**PLANNING, ENVIRONMENTAL, AND DEVELOPMENT, SERVICES DEPARTMENT
ZONING DIVISION PUBLIC HEARING REPORT**

CASE #: VA-26-05-037

REQUEST: Variances in the R-1AA zoning district from the Normal High Water Elevation as follows:
1) To allow a new residence with a setback of 16.6 ft. in lieu of 35 ft.
2) To allow a pool and deck with a setback of 3.2 ft. in lieu of 35 ft.

BZA STAFF REPORT

SITE PLAN

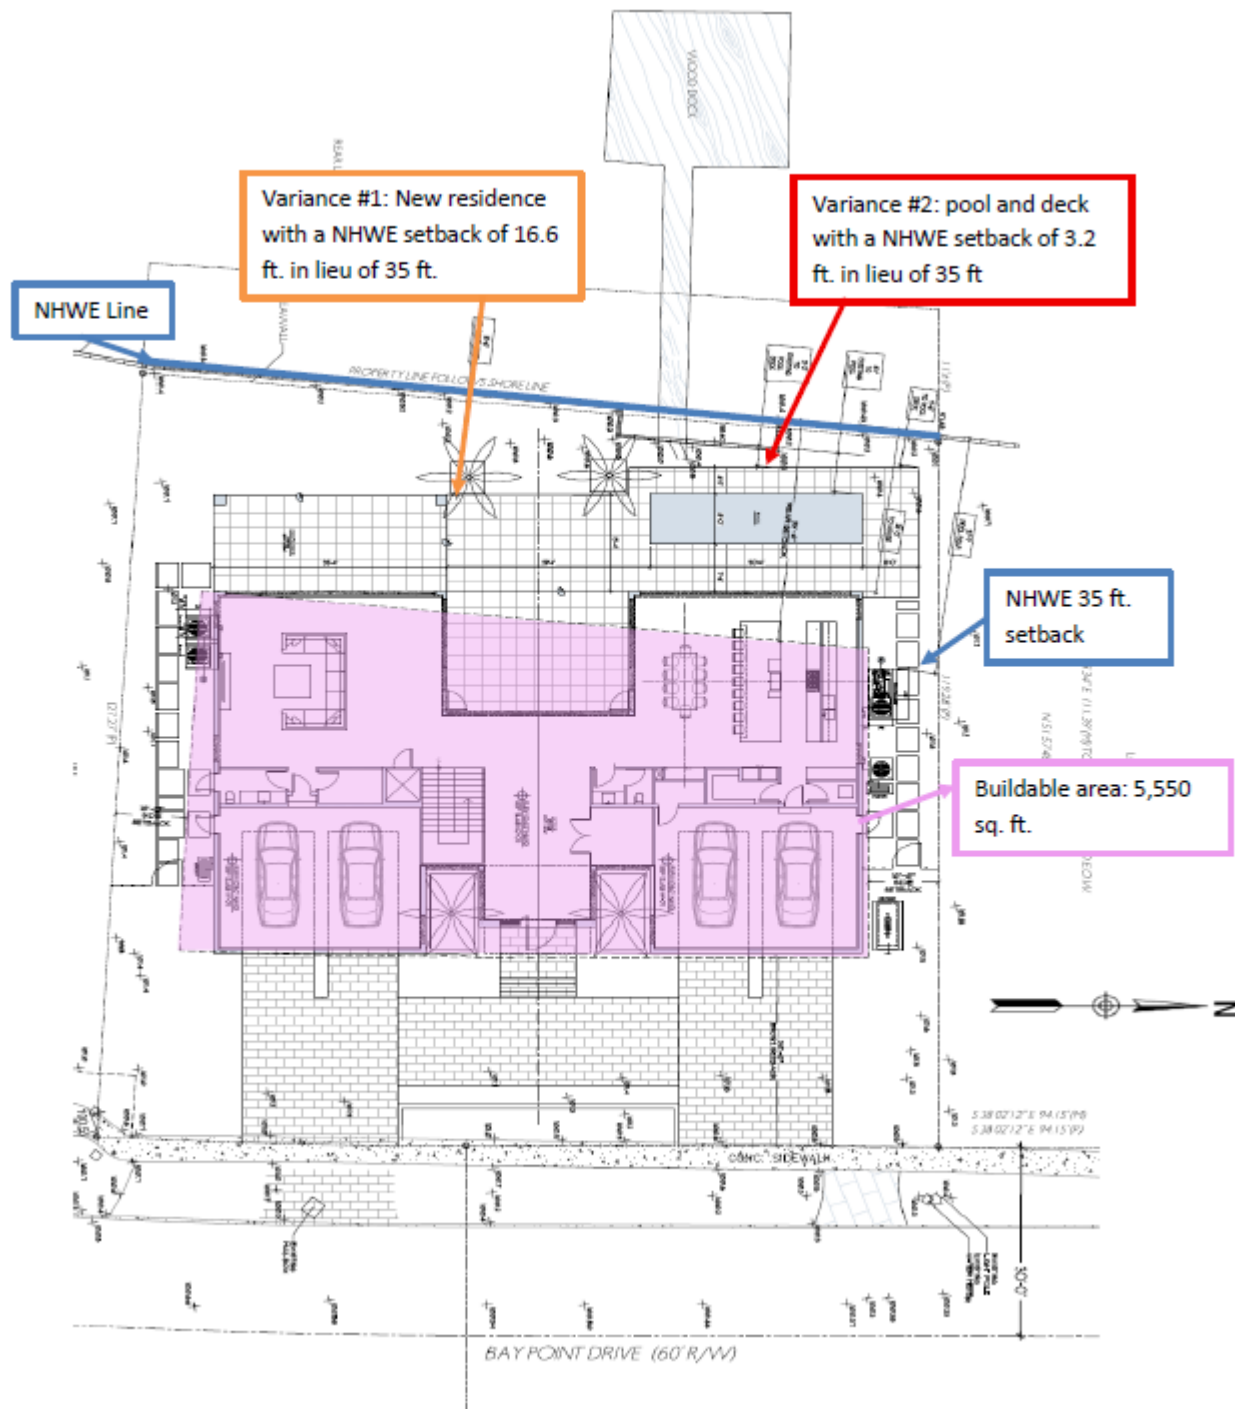
The proposal is to construct an approximately 7,800-square-foot, two-story single-family residence with two two-car garages, along with a covered patio, pool, and deck located at the rear of the home. The proposed residence is shown with a 16.6 ft. setback from the Normal High-Water Elevation (NHWE) line. The typical NHWE setback for a property located in the R-1AA district is 50 ft. However, Section 38-1501 footnote 'A' of Orange County Code states that a lot which is part of a subdivision, the plat of which has been lawfully recorded,... on or before August 31, 1982,... which has a depth of less than one hundred fifty (150) feet above the NHWE contour, shall be exempt from the 50 ft. setback requirement set forth in Section 38-1501. Instead, the setbacks under the respective zoning district requirements shall apply as measured from the NHWE contour. Lot depth is measured as the distance measured from the midpoint of the front line to the midpoint of the opposite rear line of the lot, which in this instance is the NHWE line. The property depth is approximately 135 ft.; therefore, the minimum rear setback is 35 ft. from the NHWE, and the proposed residence will not comply with this setback requirement, therefore requiring Variance #1.

Section 38-79(10)c. establishes swimming pools, including all appurtenances thereto, such as pool decks, security fences, or screen enclosures, shall be subject to the setback requirements from the NHWE contour for water bodies. Footnote 'A' of Section 38-1501 of Orange County Code states the minimum setbacks from the NHWE contour for accessory structures and uses shall be the same distance as the setbacks which are used per the respective zoning district requirements as measured from the NHWE contour. The pool and deck are proposed to be located 3.2 ft. from the NHWE line where a 35 ft. setback is required, prompting Variance #2.

Section 30-43 (3) of the Orange County Code stipulates a recommendation of approval can only be made if all six Variance criteria are met. While the Variance requests meet some of the criteria, they do not meet all the criteria. Based on staff’s analysis the residence is not yet constructed and could be redesigned to lessen the Variance requests. Therefore, staff is recommending denial.

ALL VARIANCES NOT MET – No special conditions and circumstances exist as the home has not been constructed, and the proposed construction could be redesigned in a way to comply with all setback requirements for the lot. The buildable area of the lot once all required setbacks are applied is approximately 5,550 sq. ft.

ALL VARIANCES NOT MET – The requested Variances do not represent the minimum necessary to accommodate a new single-family home, pool, and deck, as the proposed development could be redesigned to eliminate or reduce the extent of the requests.

4. Prior to the issuance of any building permit, the property owner shall record in the official records of Orange County, Florida an Indemnification/Hold Harmless Agreement, on a form provided by the County, which indemnifies Orange County, Florida from any damages and losses arising out of or related in any way to the activities or operations on or use of the Improvement resulting from the County's granting of the Variance requests and, which shall inform all interested parties that the principal structure is located no closer than 16.6 feet and the pool and deck is located no closer than 3.2 feet from the Normal High Water Elevation (NHWE) of Lake Tibet.
